UNITED STATES PATENT AND TRADEMARK OFFICE

APPLICATION NO.	FILING DATE	FIRST NAMED INVENTOR	ATTORNEY DOCKET NO.	CONFIRMATION NO.
10/711,326	09/10/2004	Takahiro Nakano	SIC-04-034	5325
29863	7590	11/19/2009		
DELAND LAW OFFICE P.O. BOX 69 KLAMATH RIVER, CA 96050-0069			EXAMINER IRVIN, THOMAS W	
			ART UNIT 3657	PAPER NUMBER
			NOTIFICATION DATE 11/19/2009	DELIVERY MODE ELECTRONIC

Office Action Summary	Application No. 10/711,326	Applicant(s) NAKANO ET AL.	
	Examiner THOMAS W. IRVIN	Art Unit 3657

DETAILED ACTION

Fig. 3(A) and 3(B)
(US 2004/0142783)

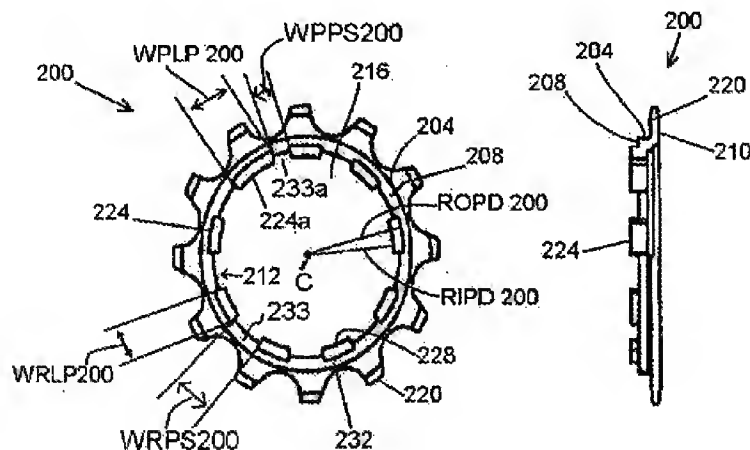
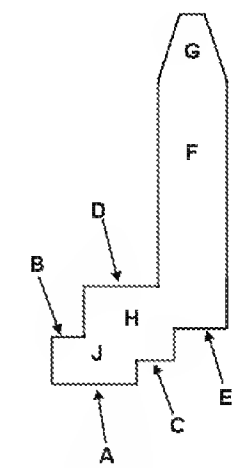
In Re claim 1, Kamada et al. disclose a bicycle sprocket comprising: a sprocket body (F); a plurality of teeth (G); a spline (224) that originates and extends radially inwardly from an innermost peripheral surface (212,C) of the sprocket body, wherein the innermost peripheral surface of the sprocket body (D) extends in a direction of the rotational axis above the spline and also extends circumferentially to form a radially outwardly extending spline (232), wherein the spline terminates in a radially inwardly facing free end (A); wherein the spline includes a radially outer surface (B) facing radially outwardly.

In Re claims 3 and 4, see fig. 3(B).

In Re claims 5 and 10, see first sidewall portion (F), and second sidewall portion (H).

In Re claim 6, see fig. 3(A).

In Re claims 7 and 8, see fig. 3(B).

In Re claim 9, see (A) and (E).

In Re claims 11 and 12, see fig. 3(B).

In Re claim 15, see fig 3(A) and surfaces (B) and (C).

In response to applicant's arguments that (B) does not face a radially inner surface of the sprocket, the examiner points out the surface (B) faces outwardly, and surface (E) faces radially inwardly, and thus face each other. The claims do not recite that they overlap in a direction orthogonal to the rotational axis of the sprocket.
